CITY OF OPELIKA HISTORIC PRESERVATION COMMISSION

August 14, 2025

City of Opelika
Historic Preservation Commission
Staff Report

Agenda Item #: 4
Meeting Date: 08/14/2025
Action Requested: COA: Replace Side Entry Door, Metal Awning, Columns
Location of Property: 213 S. 8th St; Downtown Historic District
Petitioner: The Breezeway

Current side entry

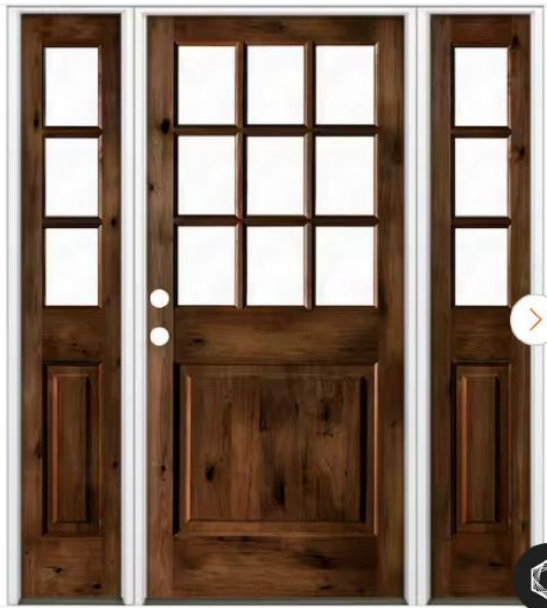
1. Replace the side entry door with mahogany 4-lite single door with sidelites.
2. Install 9”w x 90”h x 3”d fluted polyurethane pilaster molded with plinth to add architectural interest and match metal trim on front side.
3. Install 24”h x 80”w x 36” d standing seam metal awning with commercial-grade mill finish aluminum frame above entry.

- 1. Staff recommends approval of wood or fiberglass doors with sidelites to replace current wood door unit.
- 2. Staff recommends installation of fluted half pilasters. Although guidelines state architectural elements that are not original to the structure should be added, placement will be on side entrance and not the main facade.
- 3. Staff recommends approval of standing seam metal awning with 36" depth.
